SELLINDGE PARISH COUNCIL

SELLINDGE PARISH COMMENTS RE: OTTERPOOL QUARRY REF SH/08/0124

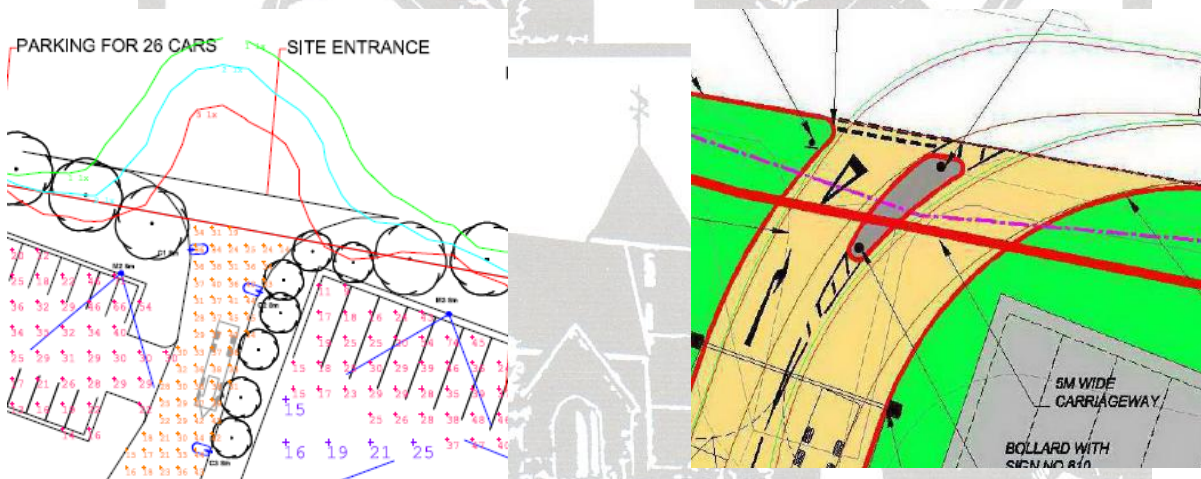
As the lighting plan was done using a plan with the entrance layout being as it is now and not as in drawing HD1. Some of the lighting will be out of place.

The plan which the lighting company used, (below left) has the entrance as it is now. They have placed 2 light columns of 8m height (indicated with  the symbol) at the entrance.

However as you can see from the extract of drawing HD1 (below right), these 2 light columns are completely misplaced.

| Lighting | 7 | As the existing entrance has been used in the plans, and assuming that the entrance as in Drawing HD1 should have been used, new plans will be needed. |
